## **Response to Submissions and Amended Concept Proposal and Stage 1 Application**

Loreto Normanhurst, 91-93 Pennant Hills Road,  
Normanhurst

Concept Plan and Stage 1 Application

08 February 2021 | 17074

**Figure 4** Key Changes Diagram

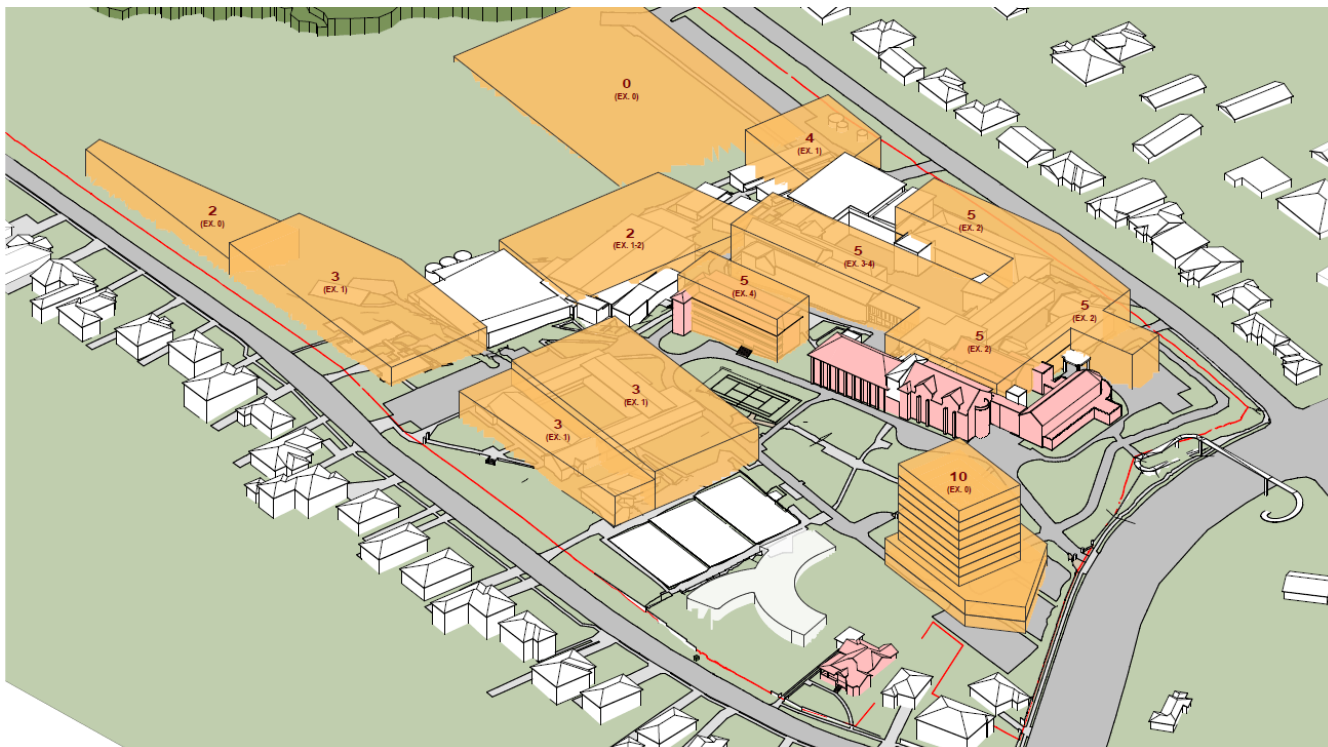
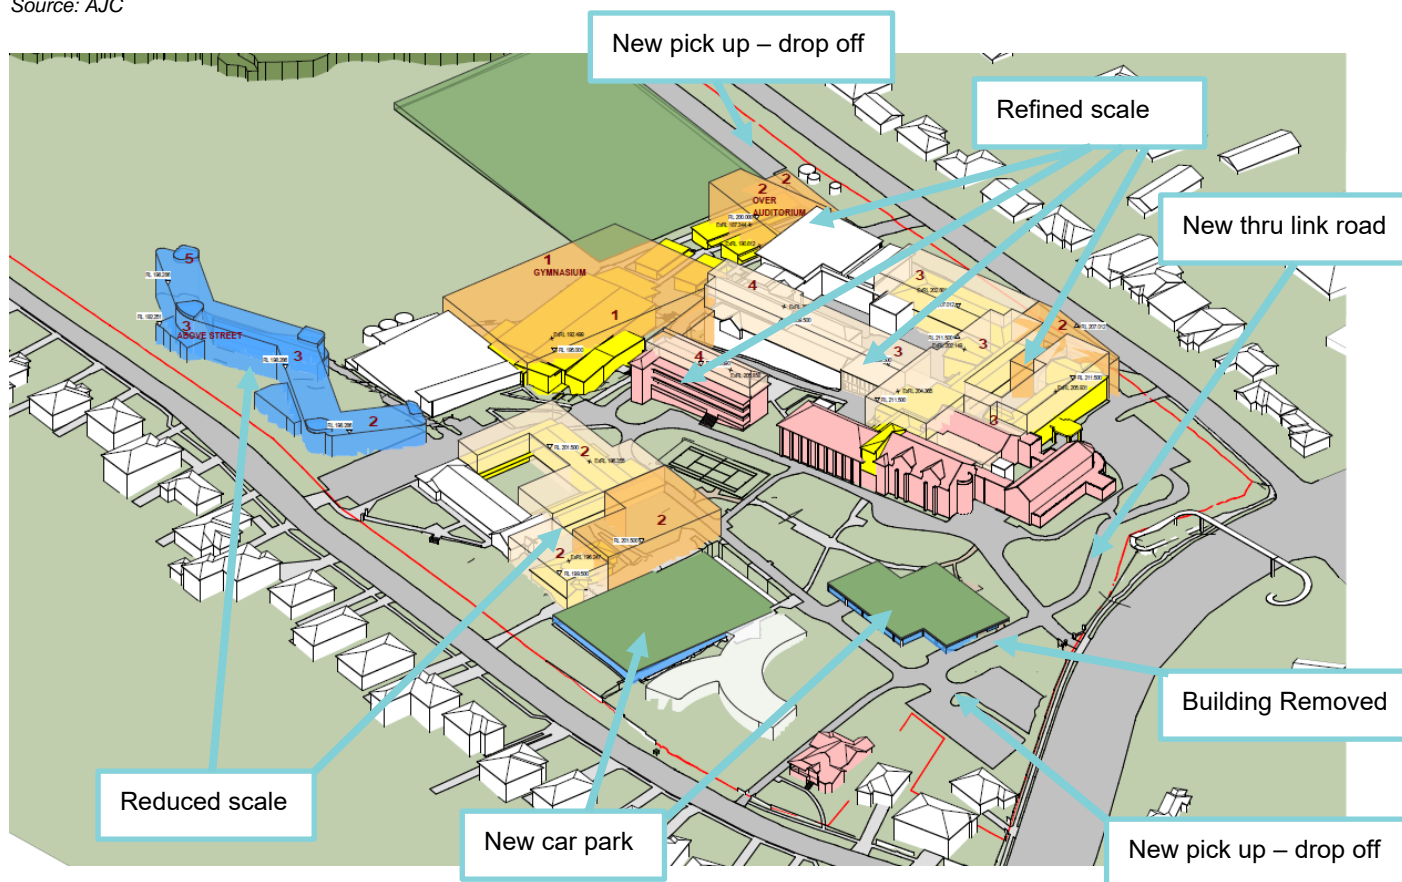
Envelope 2 and 3 of the Concept Proposal were of significant concern, particularly in relation to the existing heritage elements and items and the general bulk and scale of these envelopes.

The amended Concept Proposal envelopes have been refined to respond to key issues raised from stakeholders in the exhibition period, and to respond to the current and desired future needs of the school. The design by AJC has significantly refined the proposal envelopes, including the removal of Envelope 3. The previously proposed and amended proposed envelopes is shown at **Figure 3** and **Figure 4**.

Envelope	Changes
Envelope 1 – Boarding House	The envelope is reduced with reduction in height and increased setback to Mt Pleasant Avenue.
Envelope 2 – Secondary School	This envelope extent has been refined and the upper levels have been adjusted with form that is reflective of indicative built form more in keeping with the scale of the campus.
Envelope 3 – Pennant Hills Road Facility	This envelope has been deleted to reduce impact on heritage items and to maintain the overall scale of the campus.
Envelope 4 – Primary School	The envelope has been significantly refined.
Envelope 5 – Mary Ward Building Envelope	This envelope has been significantly refined.
Envelope 6 – New Gymnasium	Unchanged.
Envelope 7 – Gonzaga Barry – Performing Arts Centre	This envelope has upper levels have been adjusted to realign with the adjoining buildings so that it is recessed from Osborn Road.
Envelope 8 – All weather field with underground carpark	Representation of this envelope has been revised to better demonstrate that the field level is lower than Osborn Road.

Envelope 9 – Mt Pleasant Avenue Pavilion	This envelope has been deleted to reduce the loss of tree canopy coverage and impact on Mt Pleasant Avenue.
Envelope 10 – Bush Chapel	This envelope has been deleted, and now refers to landscape works only.
Envelope 12 – Pedestrian Link Bridge	Unchanged
Envelope 13 – Multi-sport (P4A) Car Park	New – to increase parking supply
Envelope 14 – Tennis Court (P1A) Car Park	New – to increase parking supply

**Figure 5** Concept DA demolition plan

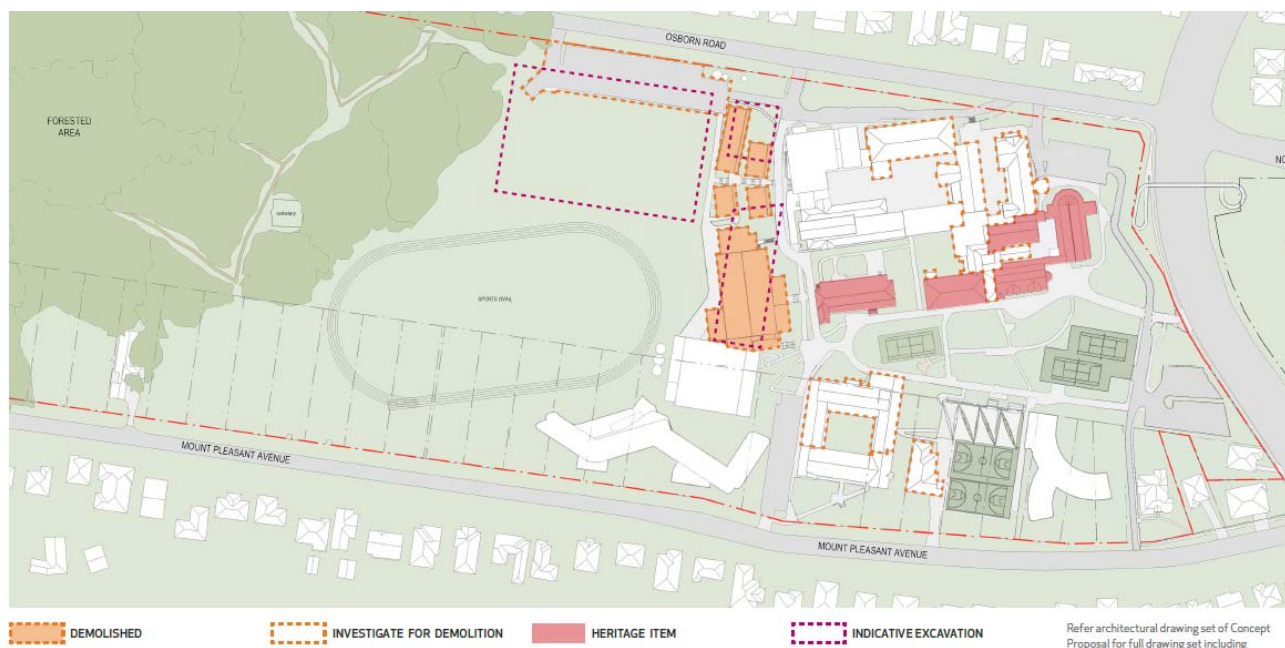
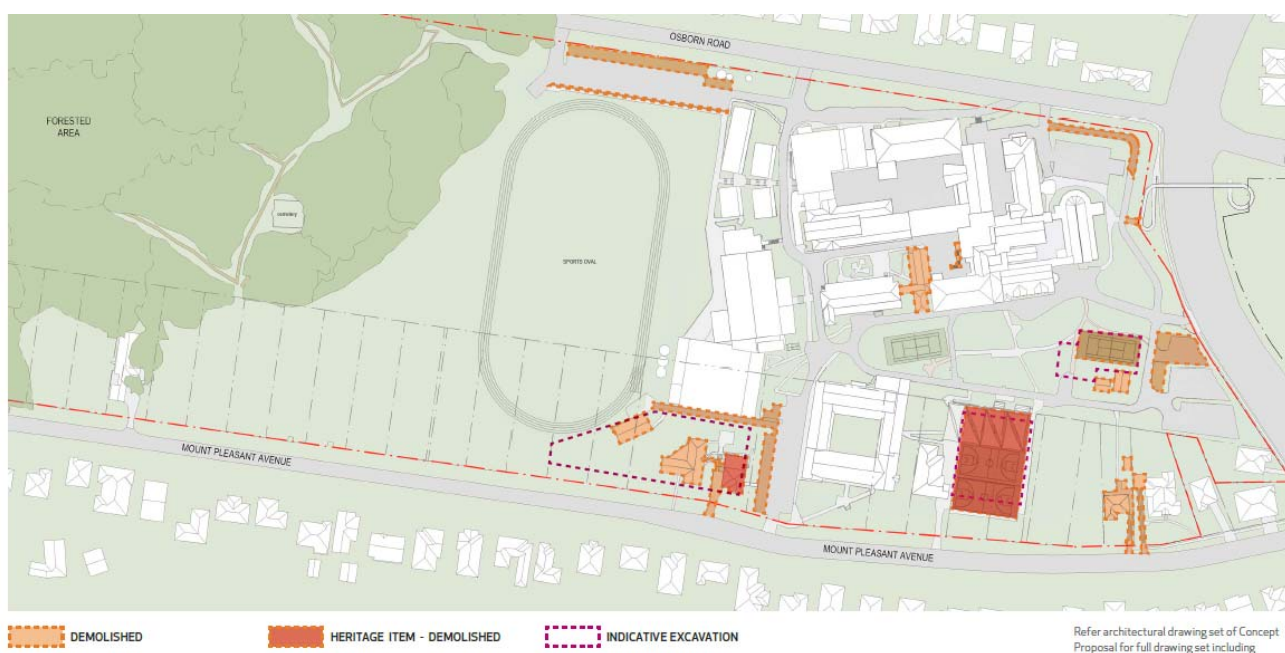
The department requested clarification on the buildings proposed to be demolished. The Design Report at **Appendix C** outlines the strategy for demolition under the Concept and Stage 1 DA, and is shown at **Figure 5** and **Figure 6** below.

It is noted the Concept DA identifies those buildings that would be subject to investigations to determine if internal demolition or demolition in part or full demolition would be required as part of a detailed DA. No approval for demolition under the Concept is sought and a separate detailed application is required for those works.

**Figure 7** Amended Stage 1 scope of works

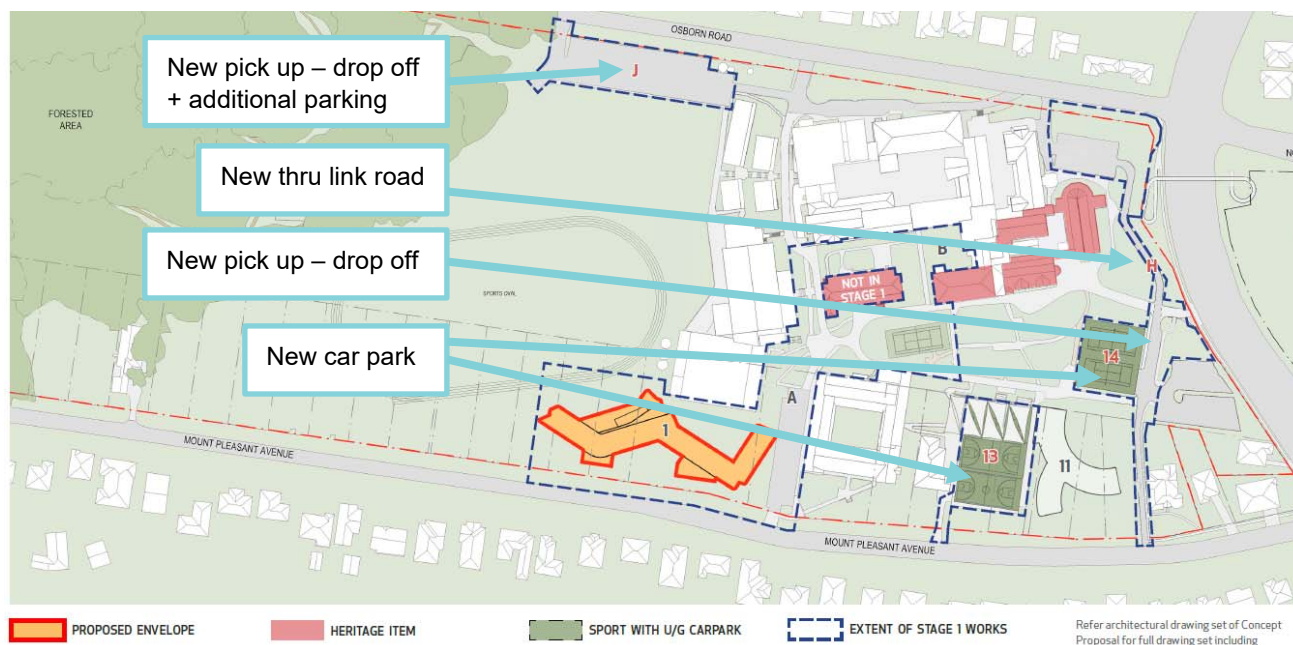
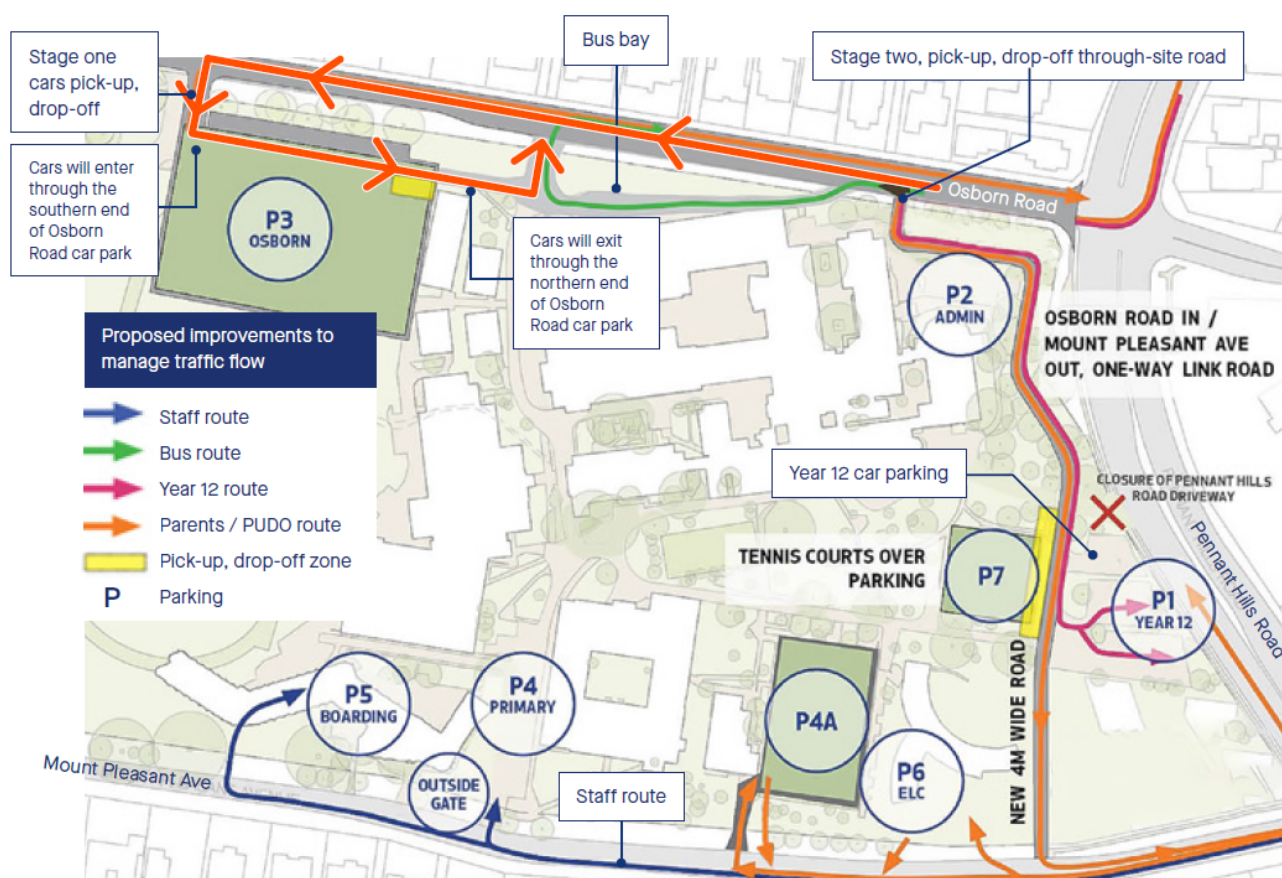
A majority of submissions raised concerns regarding existing and proposed drop off and pick up arrangements, provision of car parking on the site and the increasing number of students over the life of the masterplan and the car parking required to service this. Public submissions also noted that a significant number of cars related to the school park in the streets surrounding the school, causing traffic and access problems for residents.

In order to respond to the traffic issues identified in relation to the proposal, a number of amendments have been made to the Stage 1 scope (refer to **Section 4.0**) to incorporate better traffic and parking outcomes, including additional parking and a new through site road connection between Osborn Road and Mt Pleasant Avenue that will internalise school pick up and drop off.

**Figure 8** shows the proposed improvement to manage traffic flow around and through the school.

**Figure 9 Envelope 8 Plan view**

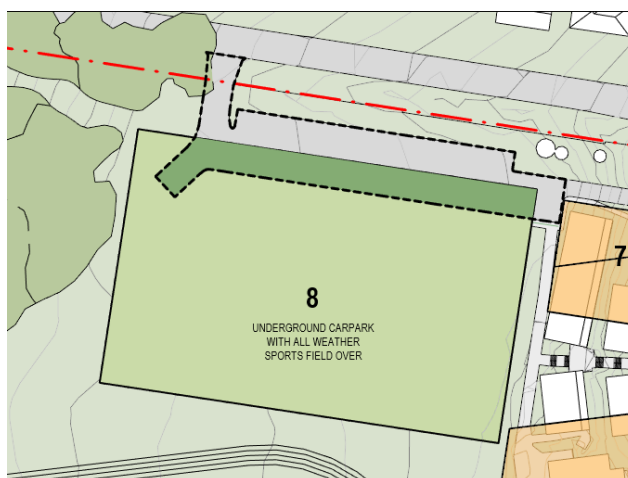
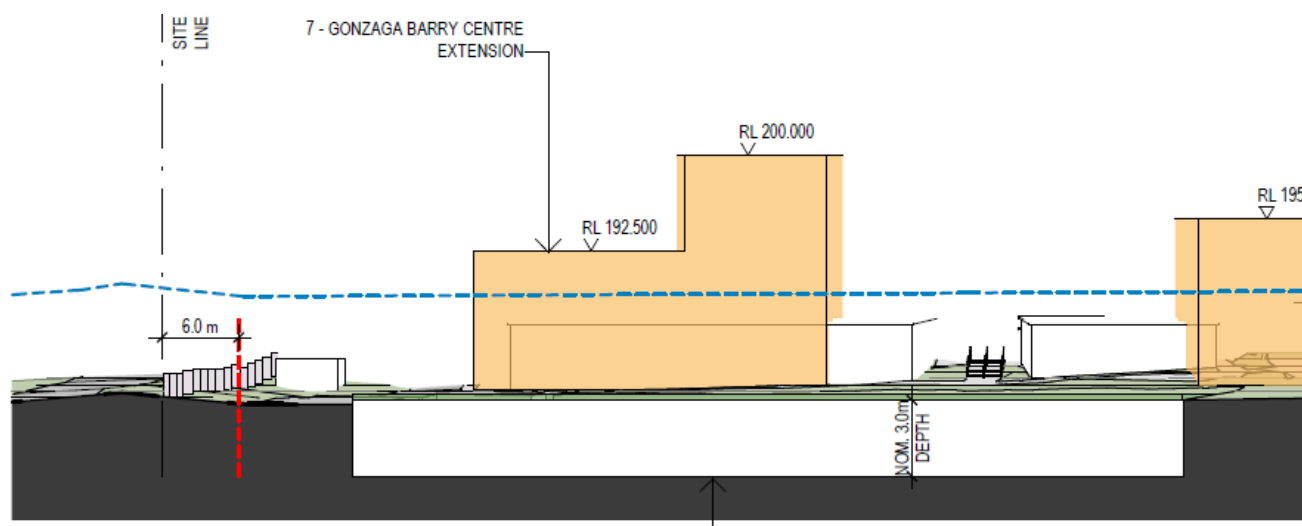
The Department raised questions in The Concept Proposal over the use and form of Envelope 8 – all weather open field with underground car park. The Department also raised concerns over tree removal and replacement planting proposed as part of the Stage 1 DA boarding house works.

Under the Concept Proposal Envelope 8 is proposed to be an all-weather playing field above an underground car park (see **Figure 9** and **Figure 10**). The car park would support up to 200 car parking spaces on a single level and would replace the existing Osborn Road car park. The playing field is generally level with Osborn Road (to the west) and the school (to the north) and the structure would not be visible from the public domain (see **Figure 11**). The topography falls to the south-east and would result in the envelope being 2 metres above existing ground at that location in a lower part of the playing field.

The future playing field will reduce the at-grade car park facing Osborne Road and will replace it with an additional 710m<sup>2</sup> playing field compared to the pre-development scenario (**Figure 9**).
